## 33.3.7.3 – PD Input Inrush Current

David Stover

# Proposed Solution: Paragraph #4, PSE-controlled Inrush

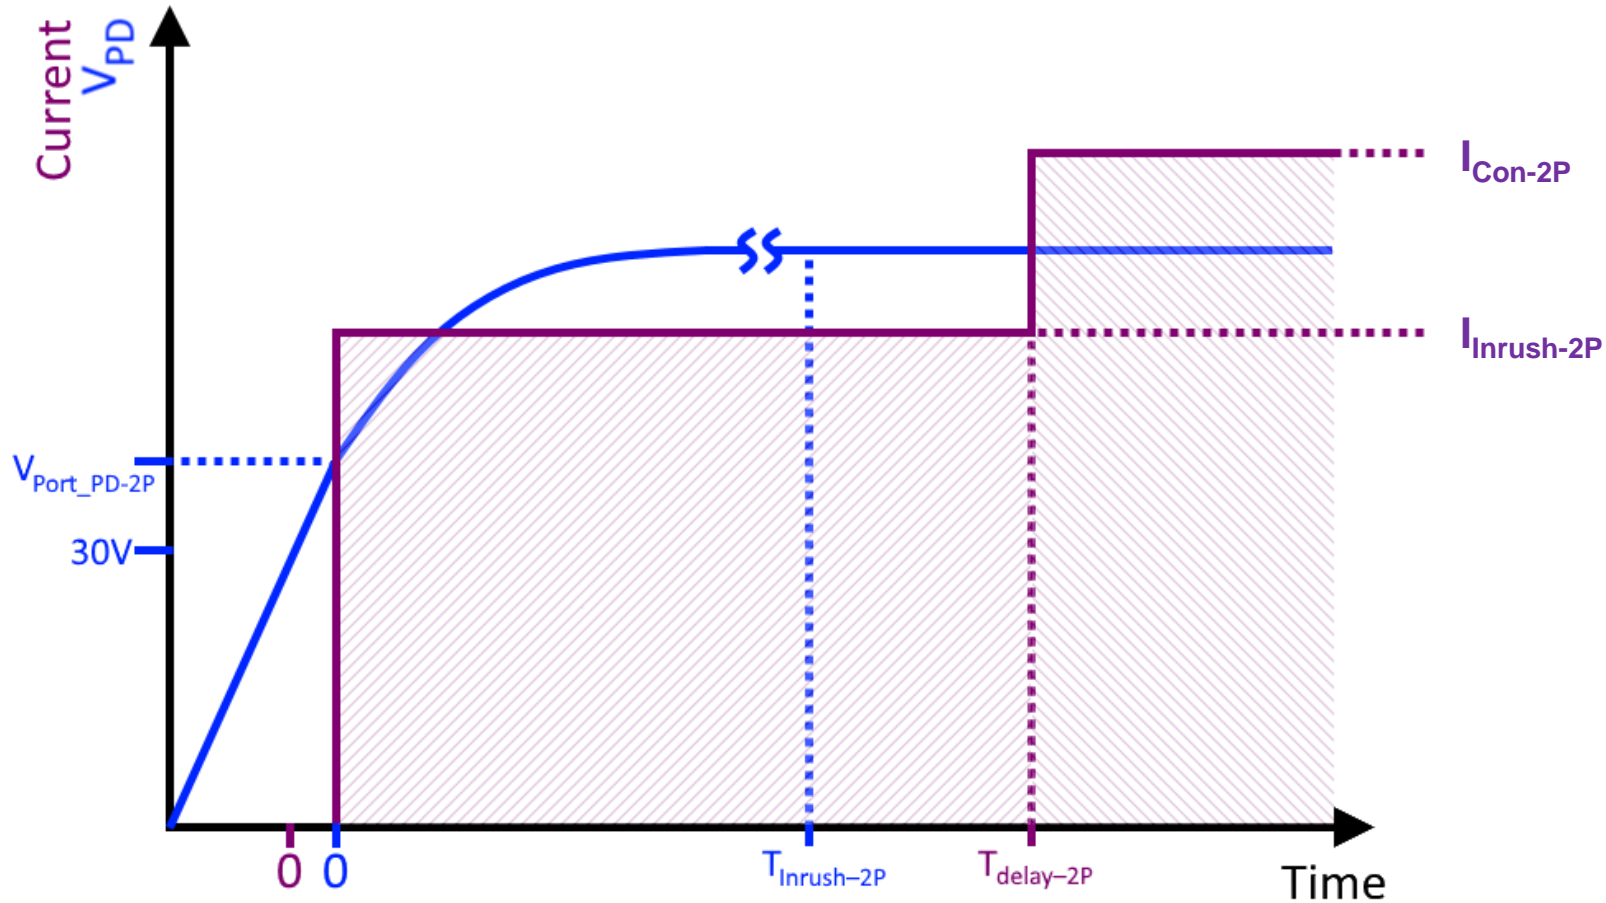
Input inrush currents at startup,  $I_{\text{Inrush\_PD}}$  and  $I_{\text{Inrush\_PD-2P}}$ , as defined in Table 33–17, are limited by the PSE if  $C_{\text{Port}} < 180 \mu\text{F}$  for single-signature PDs assigned to Class 0 to 6, and if  $C_{\text{Port}} < 360 \mu\text{F}$  for PDs assigned to Class 7 or 8. Input inrush current at startup,  $I_{\text{Inrush\_PD-2P}}$ , is limited by the PSE if  $C_{\text{Port-2P}} < 180 \mu\text{F}$  for dual-signature Type 3 PDs and if  $C_{\text{Port-2P}} < 180 \mu\text{F}$  for dual-signature Type 4 PDs. If the PSE is limiting input inrush current,  $C_{\text{Port}}$  shall be charged to 99% of its final value within  $T_{\text{Inrush-2P}}$ . If the PSE is limiting input inrush current, PDs shall conform to either  $I_{\text{Inrush\_PD}}$  and  $I_{\text{Inrush\_PD-2P}}$ , or  $I_{\text{Con}}$  and  $I_{\text{Con-2P}}$ , whichever is lower, between  $T_{\text{Inrush-2P\_min}}$  and  $T_{\text{delay-2P}}$ .

Update threshold for PSE-controlled inrush, to reflect changes in Tables 33–17 and 33–28 from D1.7.

Preserve legacy guarantee: For PSE-controlled inrush,  $C_{\text{Port}}$  shall be charged to 99% of final value within  $T_{\text{Inrush-2P}}$ .

Enforce requirements:

- PD is not allowed to transition into a high-power state prior to  $T_{\text{delay-2P}}$ .
- PD is not allowed to draw more current than its continuous current allocation (see “pd\_max\_power” usage, 33.3.3.5)

# PSE-controlled Inrush: “Whichever is lower”

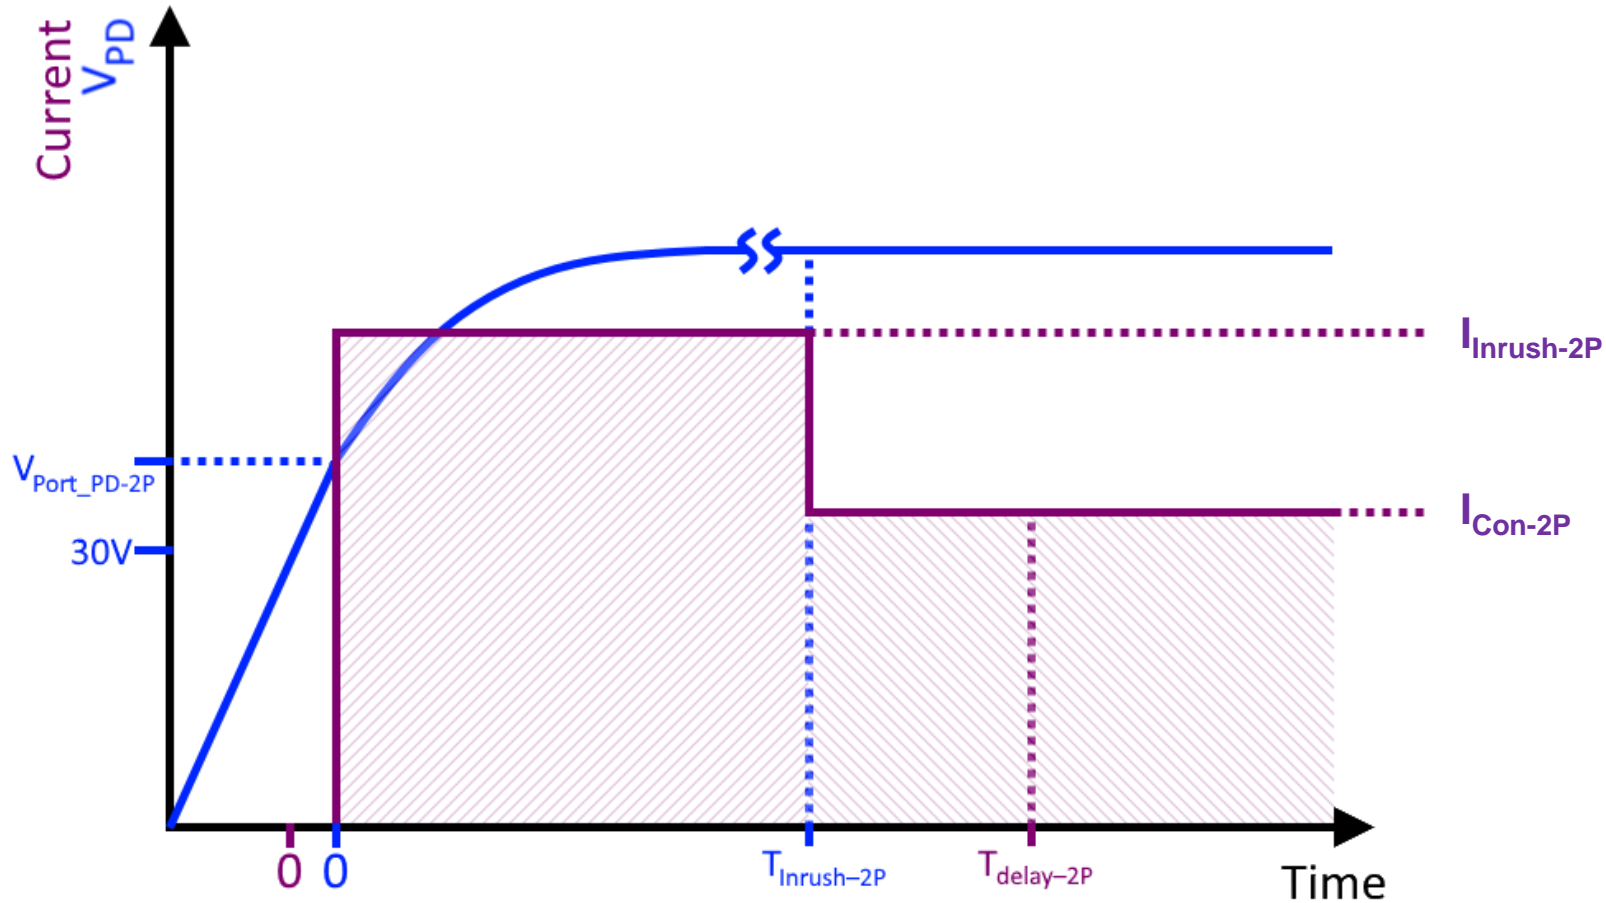
Consider the example case of PSE-controlled inrush where  $I_{Con-2P}$  is **less than**  $I_{Inrush-2P}$ , such as a Class 1 single-signature PD.

- PSE-controlled inrush means current at PD PI can reach  $I_{Inrush-2P}$  for  $T_{Inrush-2P}$
- PDs shall conform to  $I_{Inrush\_PD}$  and  $I_{Inrush\_PD-2P}$ , or  $I_{Con}$  and  $I_{Con-2P}$ , whichever is lower, between  $T_{Inrush-2P}$  min and  $T_{delay-2P}$ .

# Proposed Solution: Paragraph #6, PD-controlled Inrush

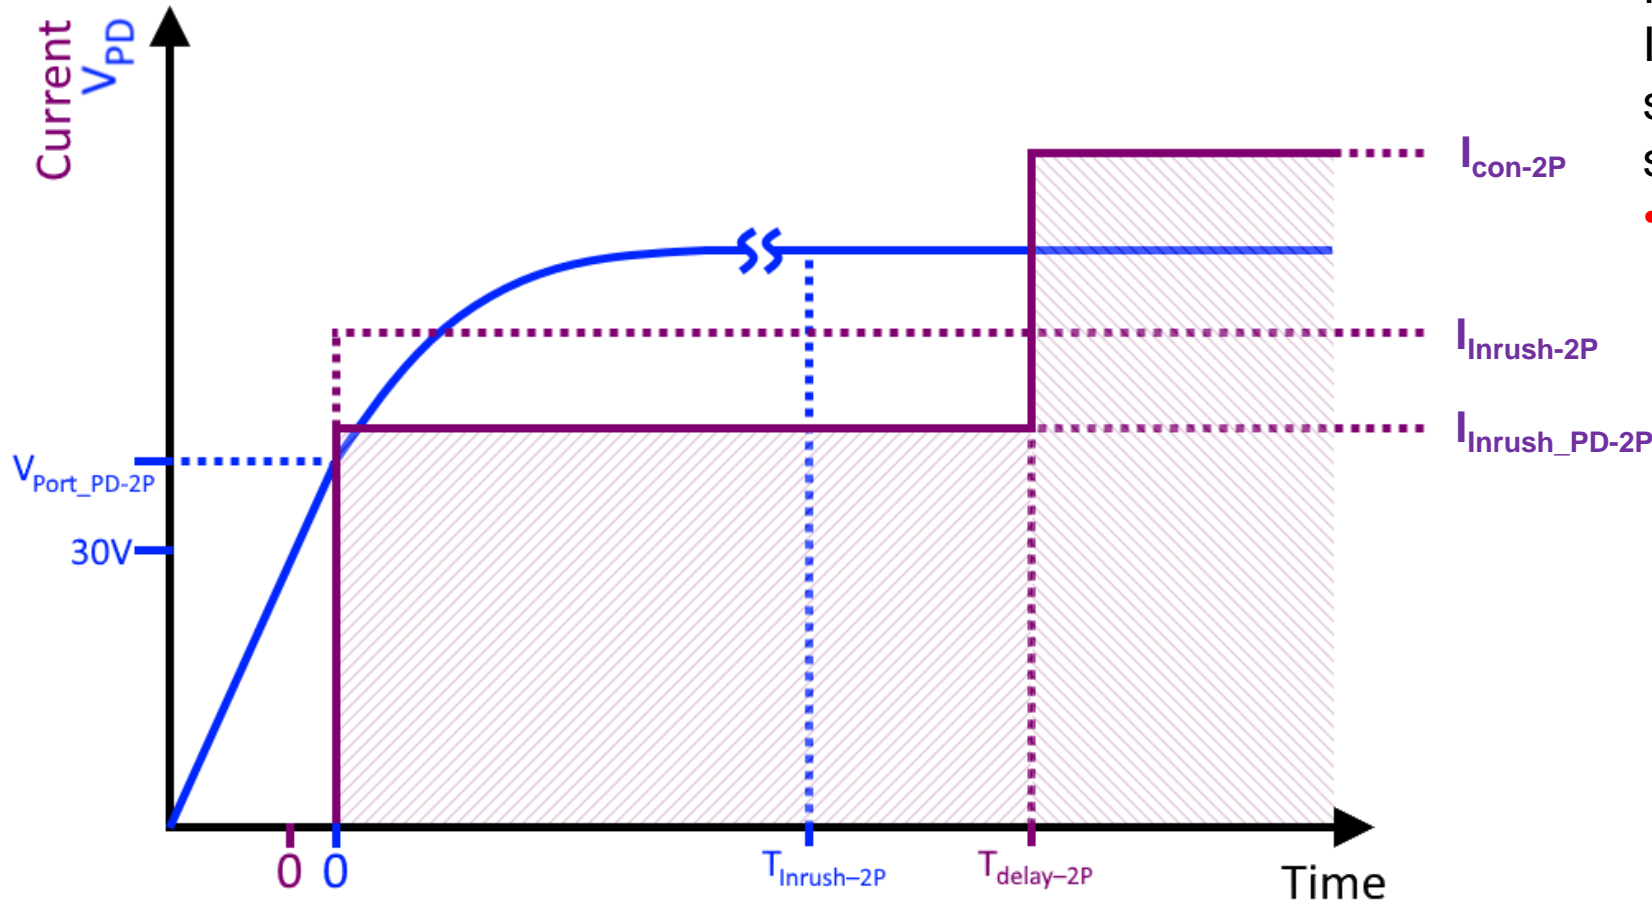
If a PD has a larger  $C_{\text{Port}}$  or  $C_{\text{Port-2P}}$  value, then the PD shall limit the input inrush current to either  $I_{\text{Inrush\_PD}}$  and  $I_{\text{Inrush\_PD-2P}}$ , or  $I_{\text{Con}}$  and  $I_{\text{Con-2P}}$ , whichever is lower, for at least  $T_{\text{delay-2P}}$  per Table 33–28, with the PSE minimum inrush behavior defined in 33.2.8.5. PDs limiting input inrush current may extend inrush beyond  $T_{\text{delay-2P}}$ . PDs limiting input inrush current should consume a lower DC load current value to guarantee positive charging current into  $C_{\text{Port}}$ .

Enforce requirements:

- PD is not allowed to transition into a high-power state prior to  $T_{\text{delay-2P}}$ .
- PD is not allowed to draw more current than its continuous current allocation (see “pd\_max\_power” usage, 33.3.3.5)

Reference from Table 33–17 is updated to Table 33–28, where PD-controlled inrush requirements live.

Explicitly state that PD-controlled inrush beyond  $T_{\text{delay-2P}}$  is allowed.

Alert the PD designer that, in the case of PD-controlled inrush, headroom above DC load current is required to allow positive charging current into  $C_{\text{Port}}$ .

# PD-controlled Inrush: “Whichever is lower”

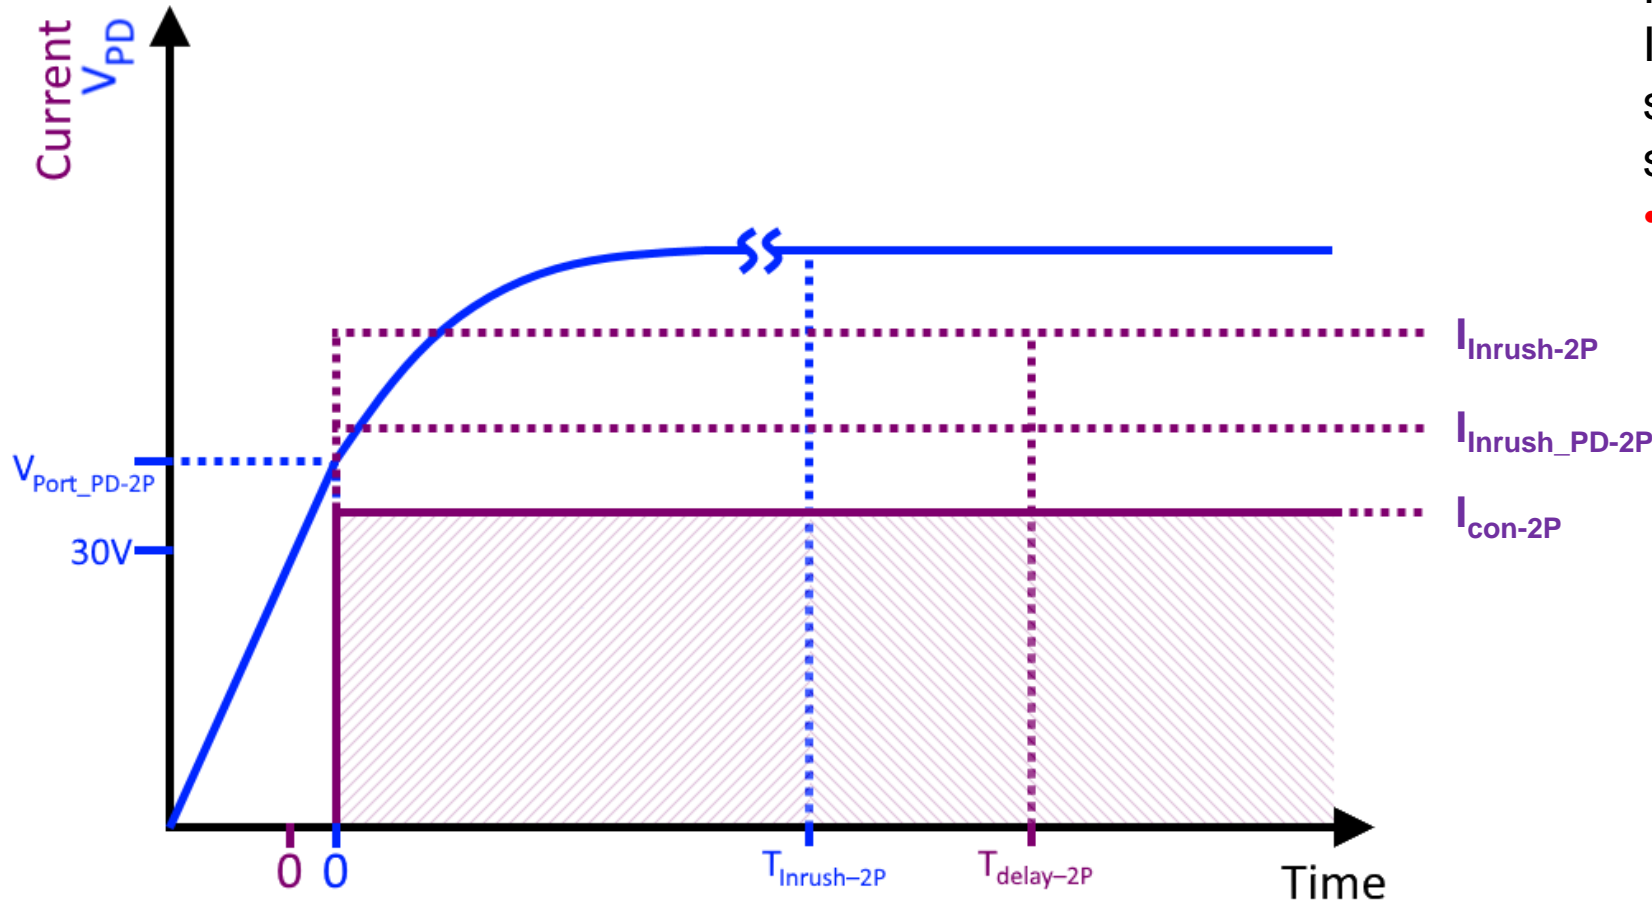
Consider the example case of PD-controlled inrush where  $I_{Con-2P}$  is **less than**  $I_{Inrush-2P}$ , such as a Class 1 single-signature PD.

- “...the PD shall limit the input inrush current to either  $I_{Inrush\_PD}$  and  $I_{Inrush\_PD-2P}$ , or  $I_{Con}$  and  $I_{Con-2P}$ , whichever is lower, for  $T_{delay-2P}$ ...”

# 802.3bt – PD Inrush Requirements: Conflict

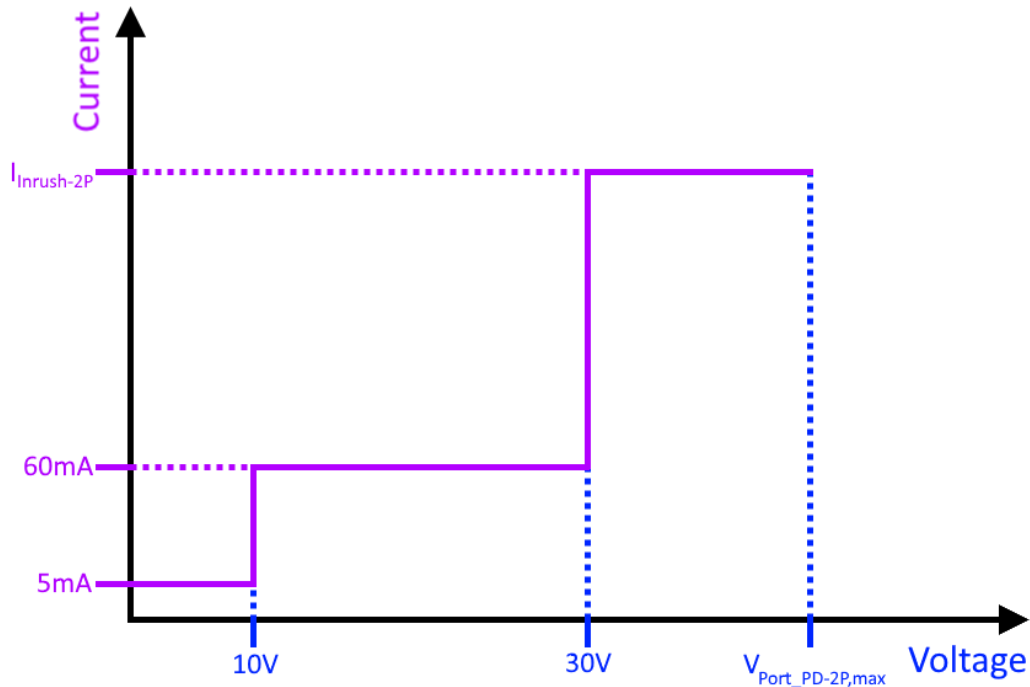
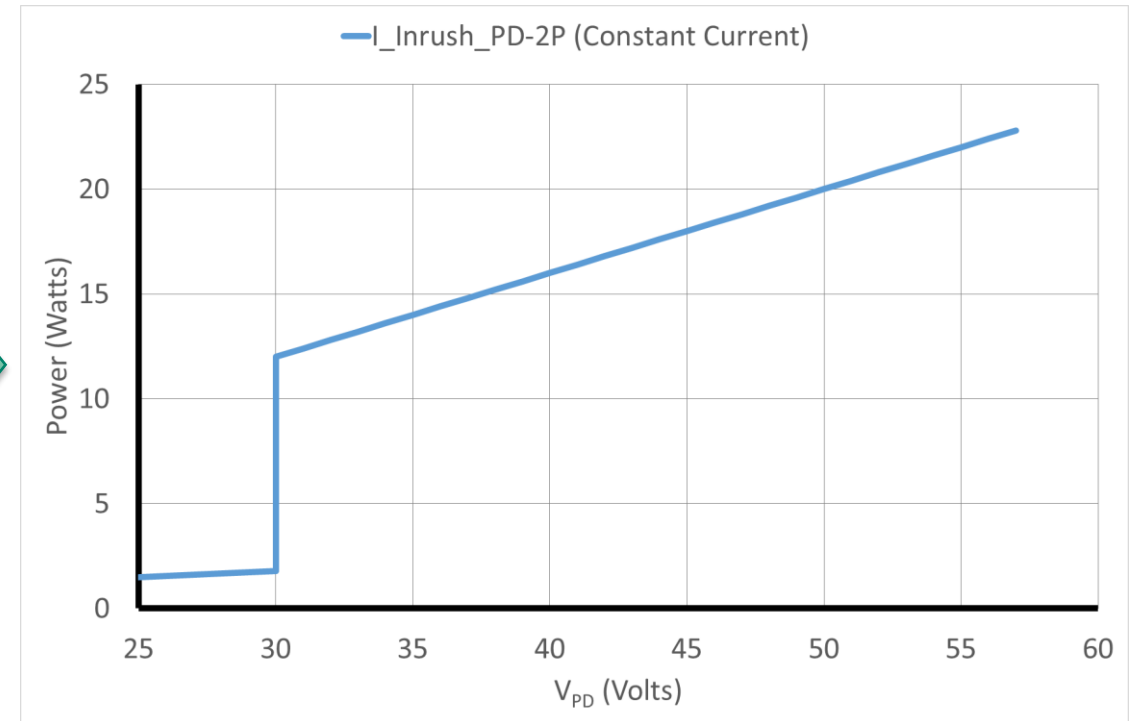
- This period shall be less than  $T_{\text{Inrush-2P}}$  min per Table 33–17, with the PSE minimum inrush behavior defined in 33.2.8.5.
- Example case:
  - Type 3 PD
    - PSE Requirement:  $I_{\text{Inrush-2P}}$  min = 400mA
    - PD Requirement (PD-controlled inrush):  $I_{\text{Inrush\_PD-2P}}$  max = 400mA

*Explicit I/V Requirements*

*Implicit Power Requirements*

# 802.3bt – PD Inrush Requirements: Conflict

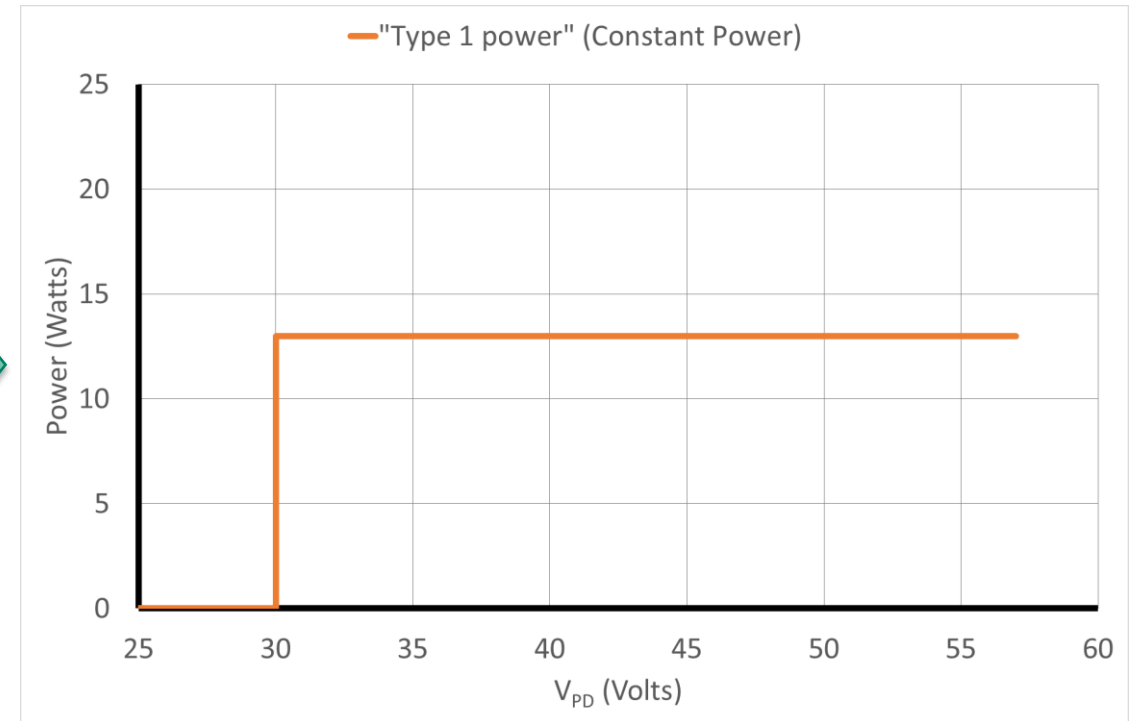
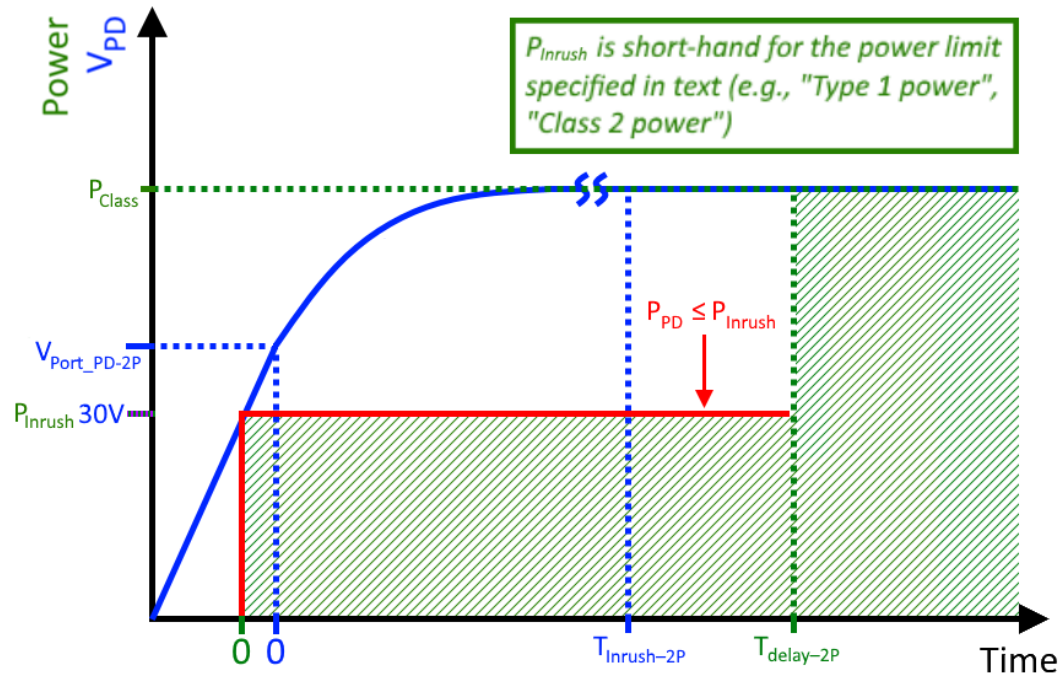
- Type 1, Type 2, and Type 3 PDs shall consume a maximum of Type 1 power for at least  $T_{\text{delay-2P}}$  min. Type 4 PDs shall consume a maximum of Class 2 power for at least  $T_{\text{delay-2P}}$  min.
- **Same example case:**
  - Type 3 PD
    - PD Requirement: “Type 1 power” max = 13W

Explicit Power Requirements

## 802.3bt – PD Inrush Requirements: Combined

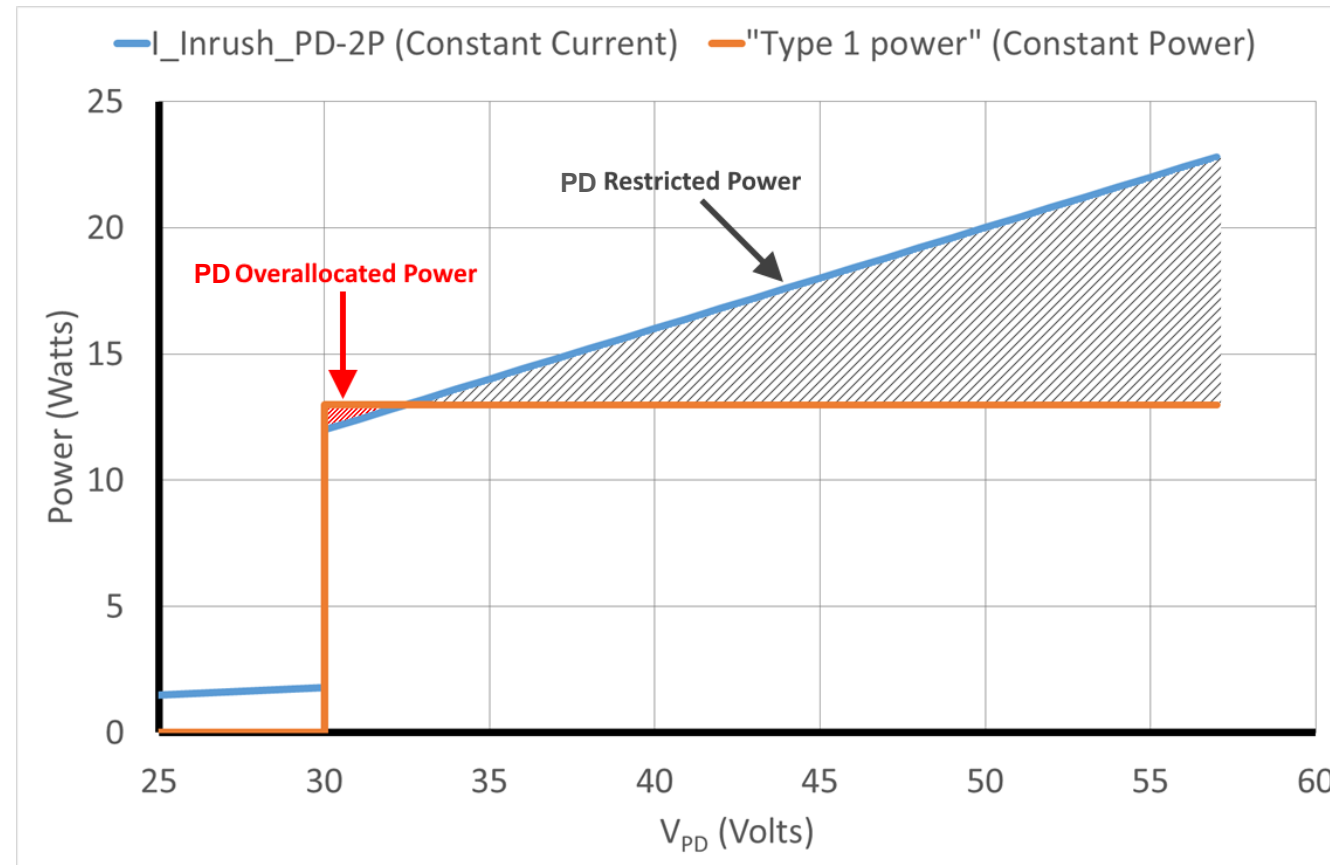
- “Type 1 power” requirement for our example case (Type 3 PD)
  - **Allocates PD power budget higher than PSE minimum at low voltage**
  - Restricts PD power budget beneath PSE guaranteed minimum and PD maximum ( $I_{\text{Inrush-2P}}$ ,  $I_{\text{Inrush\_PD-2P}}$ ) at high voltage
